Re: Request for Permit Amendment and Change to Post Mining Land Use Designation
Eureka Mills Superfund Site
Permit No: M/049/047, Lime Peak Quarry

Application for Mineral Mine Plan Revision or Amendment

Operator: Shaw Environmental Inc.			
Mine Name: Lime Peak Quarry		File Number: M/049 / 047	
Provide a detailed listing of all changes to the mining and reclamation plan that will be required as a result of this change. Individually list all maps and drawings that are to be added, replaced, or removed from the plan. Include changes of the table of contents, section of the plan, pages, or other information as needed to specifically locate, identify and revise or amend the existing Mining and Reclamation Plan. Include page, section and drawing numbers as part of the description.			
DETAILED SCHEDULE OF CHANGES TO THE MINING AND RECLAMATION PLAN			
			DESCRIPTION OF MAP, TEXT, OR MATERIALS TO BE CHANGED
<input type="checkbox"/> ADD	<input checked="" type="checkbox"/> REPLACE	<input type="checkbox"/> REMOVE	Existing pages 5 and 14 of the Notice of Intent.
<input type="checkbox"/> ADD	<input checked="" type="checkbox"/> REPLACE	<input type="checkbox"/> REMOVE	Existing Attachment I with

8

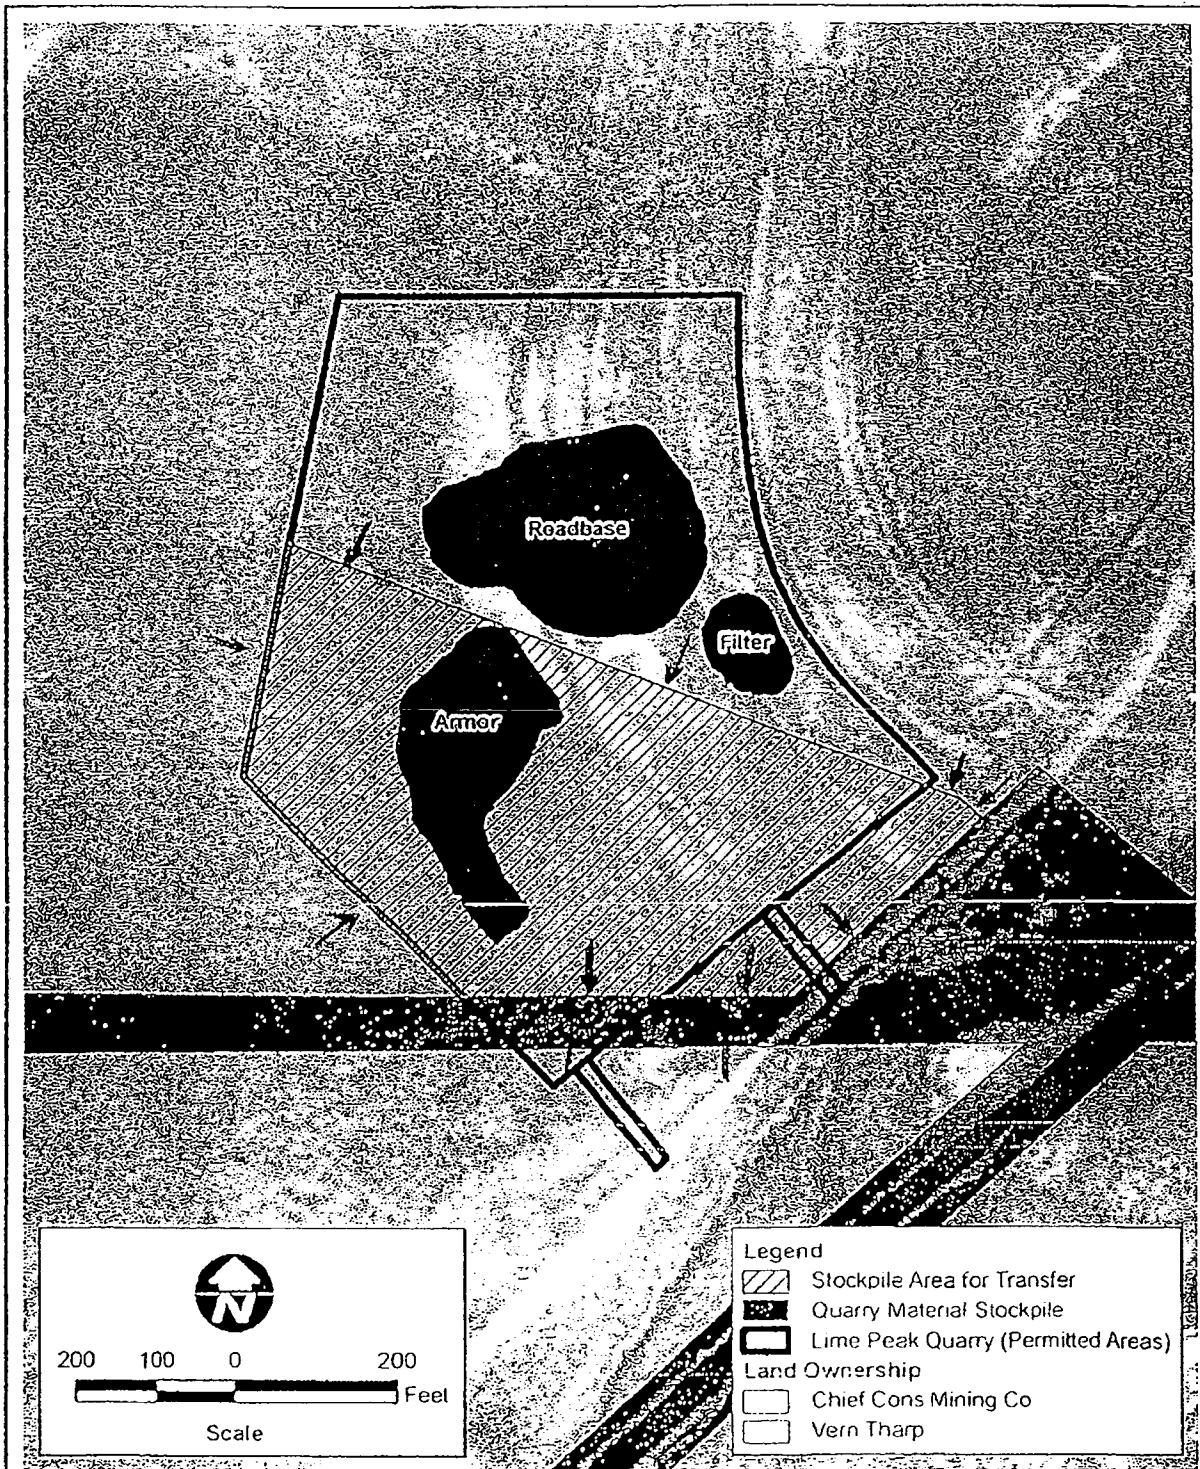
As shown in Figures 5 and 5a of Attachment II and Attachment VII, an Easement has been granted by Chief Consolidated Mining Company in favor of the City of Eureka, UT for a portion of the rock processing area at the Homansville Site. A legal description of the affected area is provided on Figure 5a. It is request the affected area be reclassified for Industrial Use for future post mine land use as indicated in Section VII of this document.

The affected area, for which an easement has been granted by Chief Consolidated Mining in favor of the City of Eureka (Attachment VII), will be used by the City for the storage of topsoil and roadbase materials. Upon completion of the remedial action at the Eureka Mills Superfund Site the EPA will leave the city 20,000 cubic yards each of the topsoil and roadbase products. These materials will be used by the city to support future Institutional Control requirements.
